AMENDMENT A001: Adjust base elevation of special rock embankment

SPECIAL 252-A

SPECIAL ROCK EMBANKMENT

AMMENDMENT A002: Remove 14-inch depth concrete from project.

CONCRETE CURB, 14-INCH DEPTH

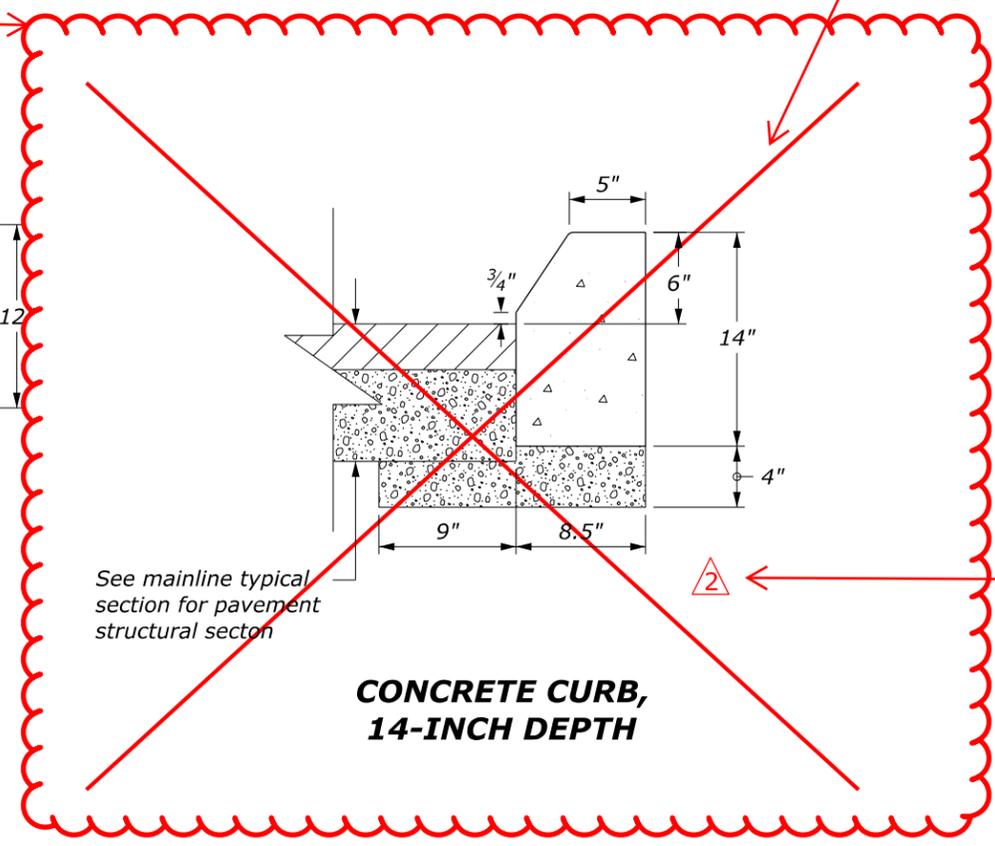
Strike-through deleted work. Do not delete.
